Pre Bid Addendum #1

Project: Mt. Haley Township Hall Addition and Alterations

Date: September 19, 2024

A3

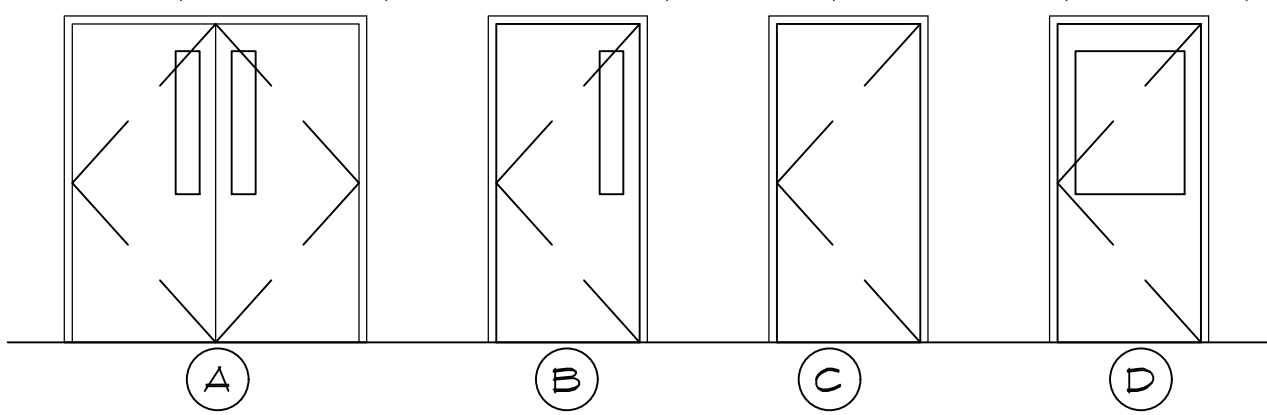
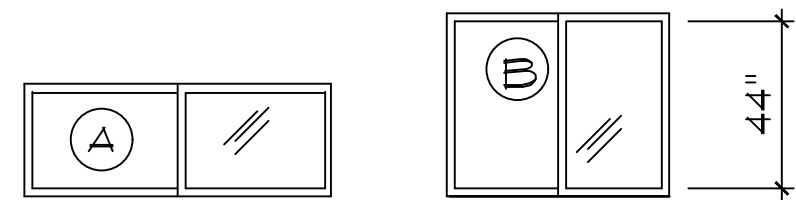
1. Sheet CS Cover Sheet notes what drawing sets in Pre Add. #1.
2. Sheet A1 Site Plan shows sitework, parking, new asphalt and stone drive areas.
3. Sheet A3 plan and schedule updates.
4. Ceramic tile floor allowance \$10/sf @ 500 sf \$5000.00
5. 1x4 square red oak base board at carpet, stained to match interior door stain, TBD.
6. Allowance for carpet squares \$6.00/sf @ 900 sf \$5400.00
7. Door and hardware schedule (see attached) Allen Supply.
8. Drywall on addition walls to be 5 /8" to best accommodate door frames.
9. Sheet A3 for updated door numbers.
10. Sheet A4 Shows door '1' on the north elevation.
11. Sheet M1 for updated furnace and condenser resizing and ductwork.
12. Sheet P2 for gas line location option.
13. Allowance for cabinetry \$300/LF = \$21,000.00 door style TBD.
14. Allowance for Formica countertops \$45/sf. \$6000.00 Color TBD.

NUMB.	SIZE	TYPE	LOCATION	MATERIAL
①	6'x6'-8"	A	REPLACE EXISTING NORTH ENTRY	HM
②	3'x6'-8"	B	NEW NORTH ENTRY LOCATION	HM
③	3'x6'-8"	C	NEW SOUTH ENTRY LOCATION	HM
④	3'x6'-8"	-	EXISTING DOOR TO REMAIN/ NEW PAINT	HM

NUMB.	SIZE	TYPE	RATING	COMMENTS	MATERIAL
⑤	3'x6'-8"	C	45 MIN.	MECHANICAL ROOM	HM
⑥	3'x6'-8"	D		RECEPTION AREA NORTH ENTRY	WOOD
⑦	3'x6'-8"	C		OFFICE 1	WOOD
⑧	3'x6'-8"	C		OFFICE 2	WOOD
⑨	3'x6'-8"	C		OFFICE 3	WOOD
⑩	3'x6'-8"	C		OFFICE 4	WOOD
⑪	3'x6'-8"	C	90 MIN.	FILE ROOM- 1 HOUR DOOR.	WOOD
⑫	3'x6'-8"	C		HALLWAY (WEST DOOR)	
⑬	3'x6'-8"	B		HALLWAY (EAST DOOR) THROUGH EXISTING BUILDING WEST WALL.	HM
⑭	3'x6'-8"			REST ROOM DOOR	WOOD

A4

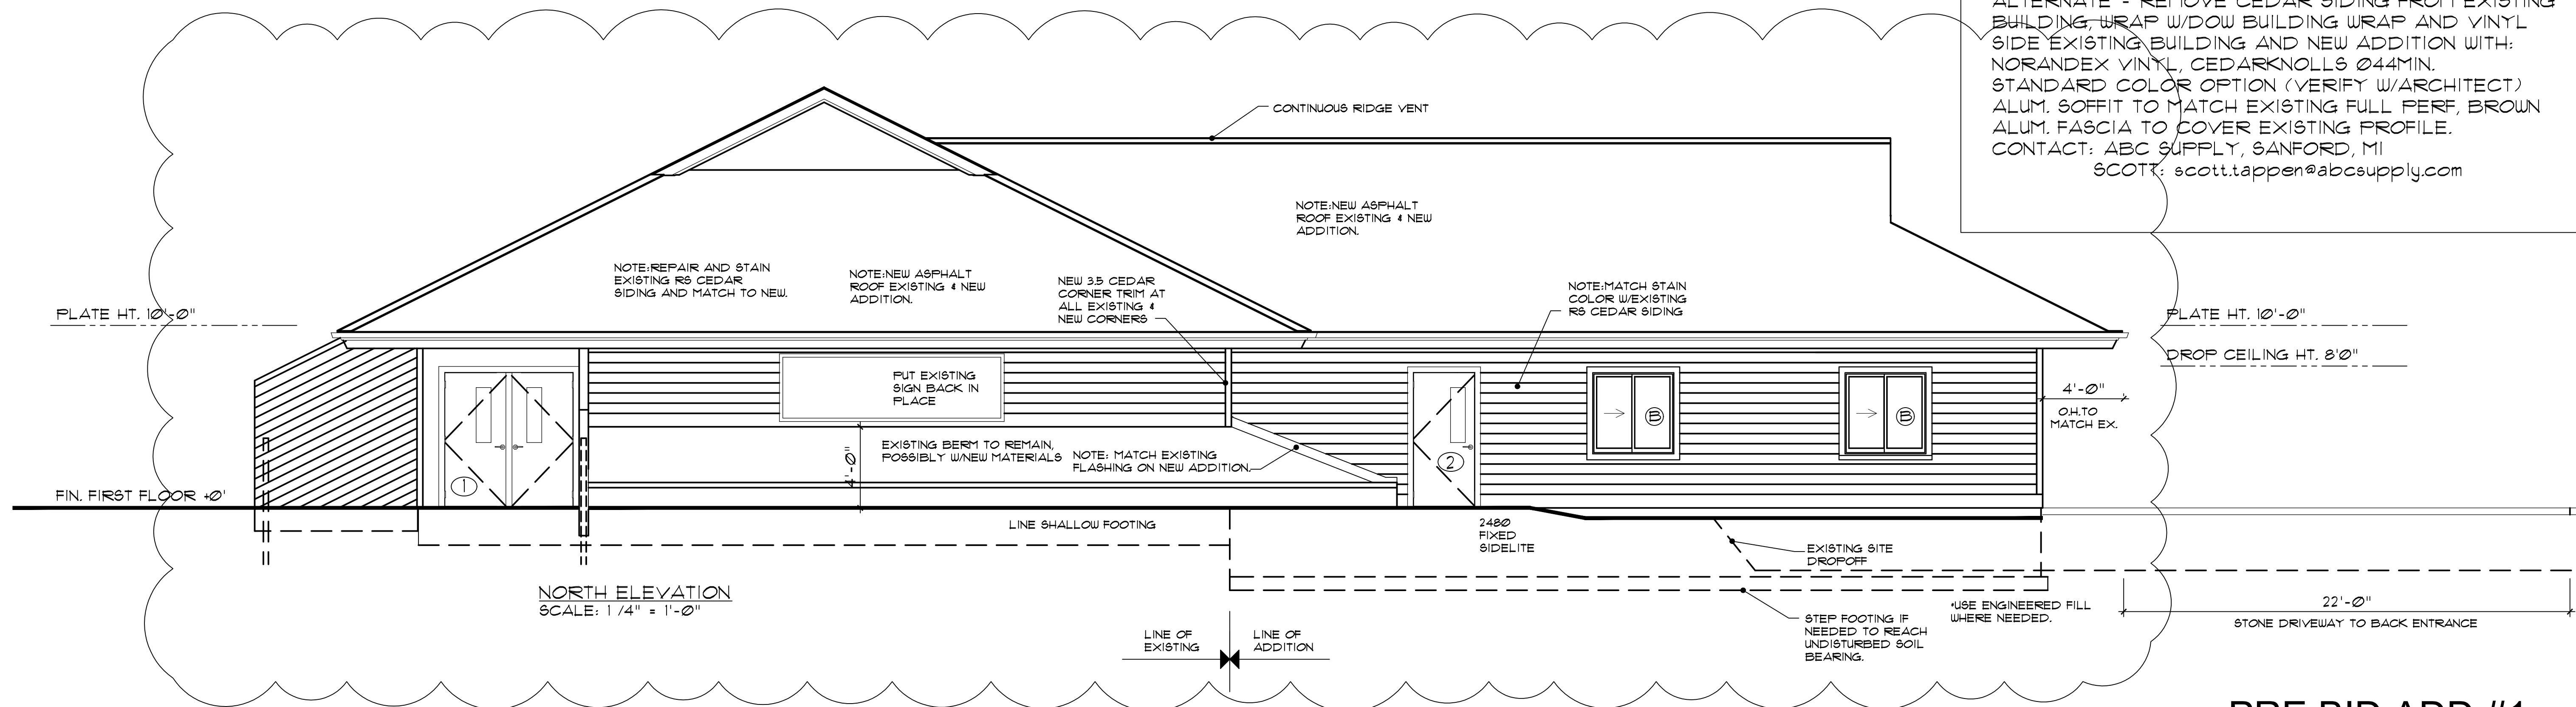
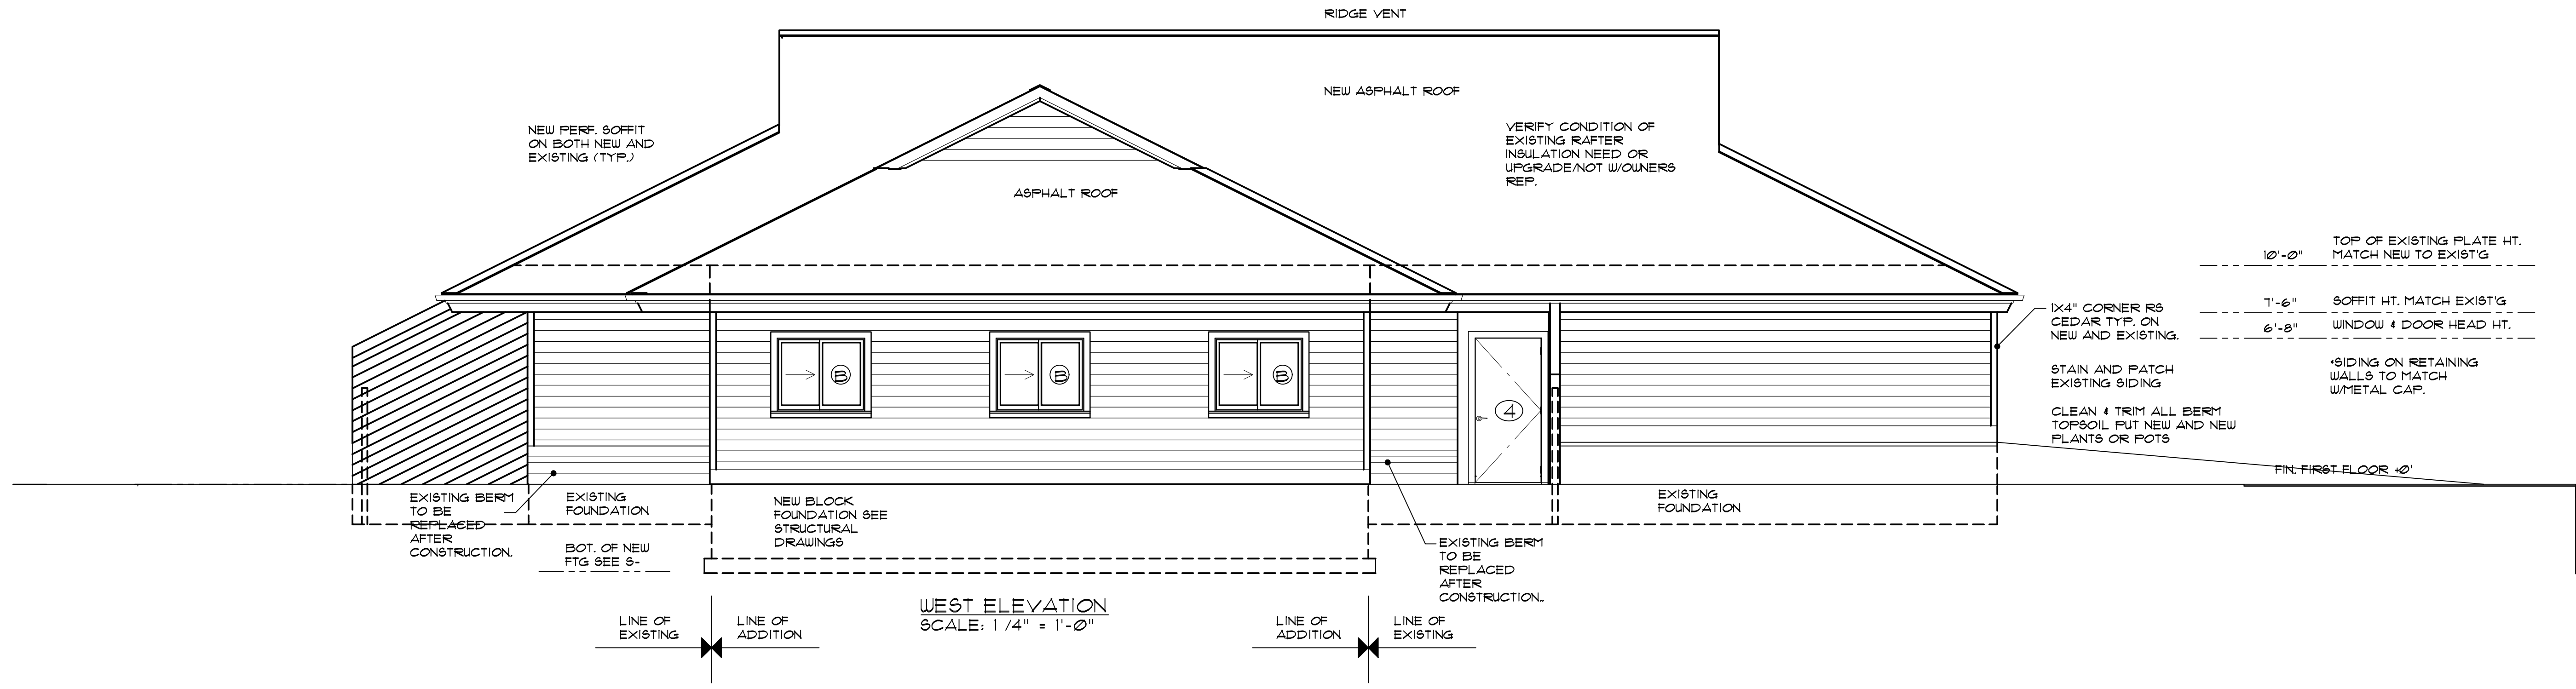
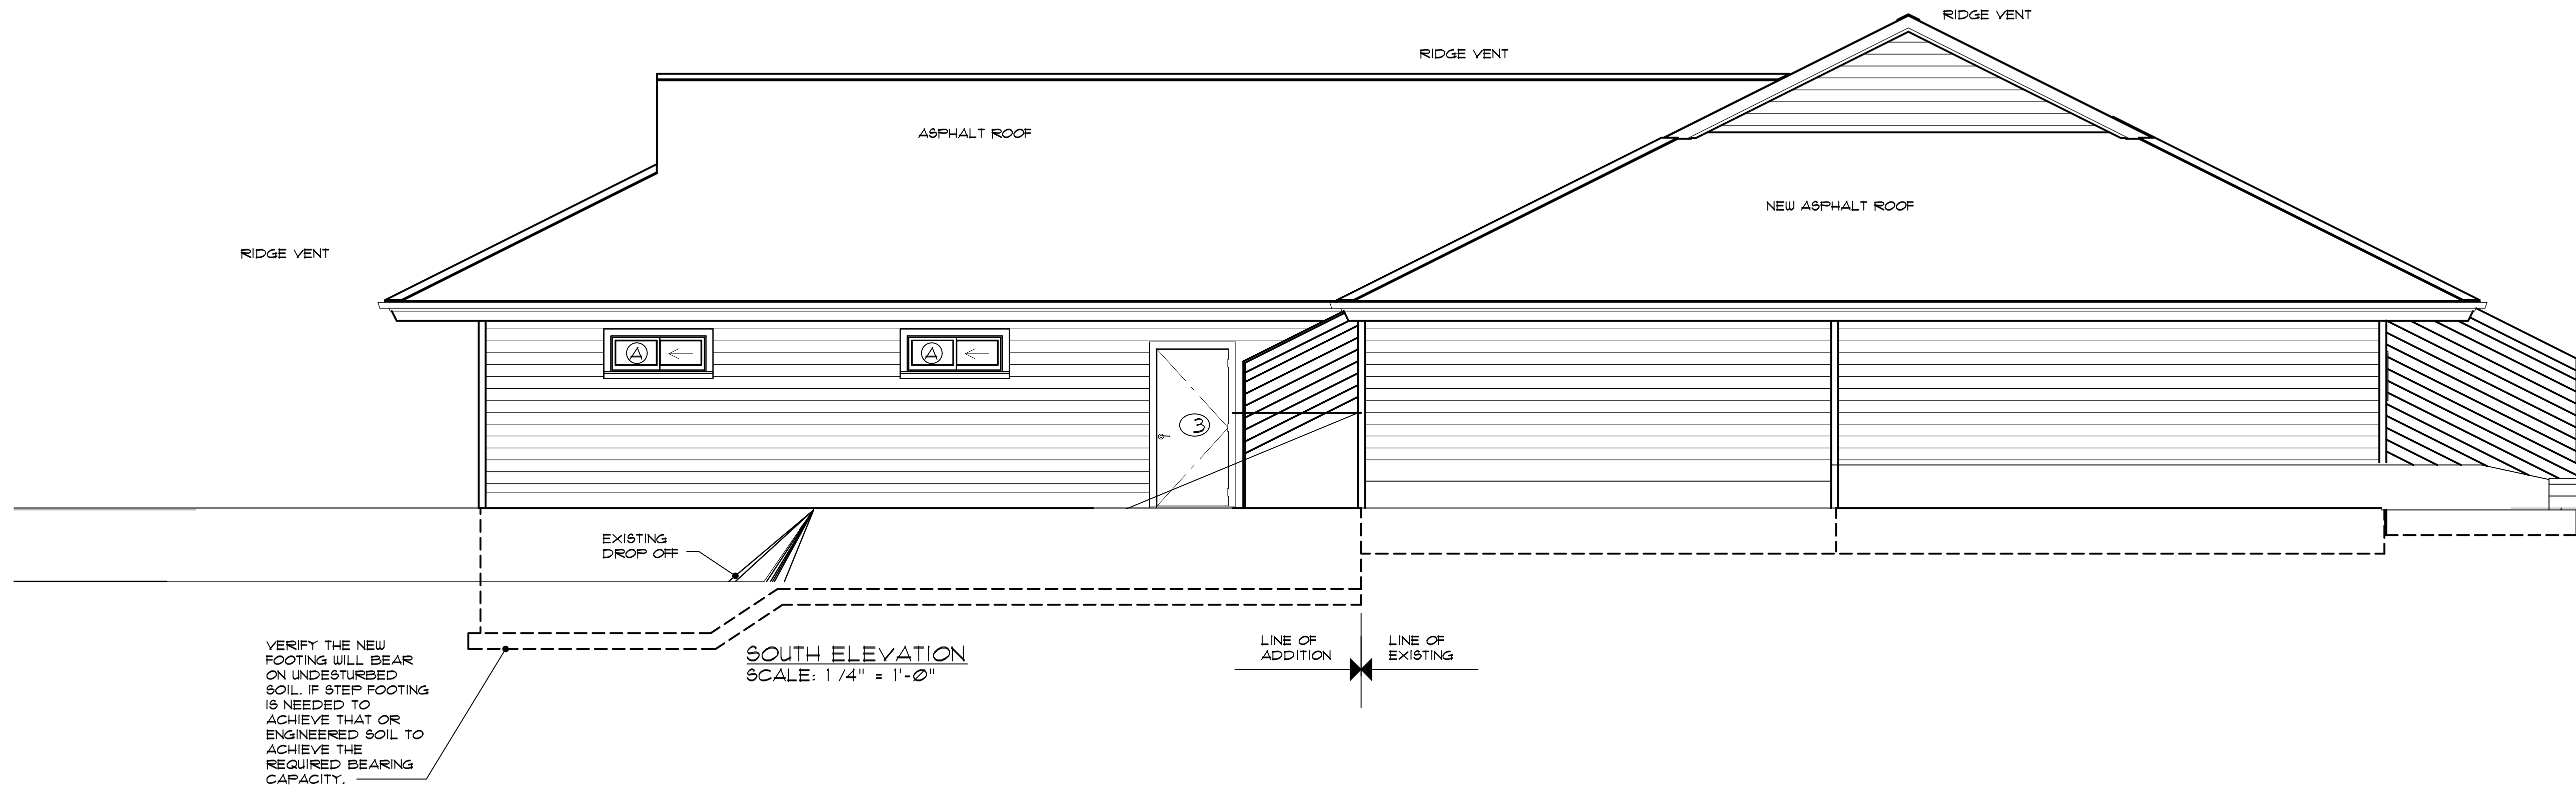
#1 - ROUGH SAWN CEDAR ON THE NEW BUILDING TO MATCH EXISTING. PATCH EXISTING AND PUT NEW 1 X4 CORNERS ON EXISTING AND NEW ADDITION. SEE ATTACHED INFORMATION FROM CROSS AND LINCOLN OUT OF HEMLOCK, MI, SAME OR SIMILAR.

ALTERNATE - REMOVE CEDAR SIDING FROM EXISTING BUILDING, WRAP W/DOW BUILDING WRAP AND VINYL SIDE EXISTING BUILDING AND NEW ADDITION WITH: NORANDEX VINYL, CEDARKNOLLS Ø44MIN. STANDARD COLOR OPTION (VERIFY W/ARCHITECT) ALUM. SOFFIT TO MATCH EXISTING FULL PERF, BROWN ALUM. FASCIA TO COVER EXISTING PROFILE. CONTACT: ABC SUPPLY, SANFORD, MI SCOTT: scott.tappen@abcsupply.com
